ACURA ServiceNews

BSN 15783 (9304)

Integra Fuel and Emissions Changes

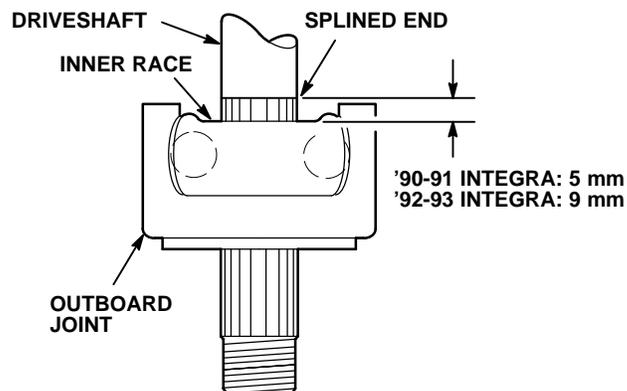
The engine coolant temperature sensor and intake air temperature sensor troubleshooting flowcharts (codes 6 and 10) in the '91 Integra S/M contain some errors. Correct pages 11-43 and 11-47 as follows:

Correction 1: Near the end of both flowcharts, the step where you connect the test harness should read, "Connect the PGM-FI test harness to the ECU only, not to the main wire harness."

Correction 2: If you get a 5V reading in the next to the last step in both flowcharts, the cause could be either a or an open.
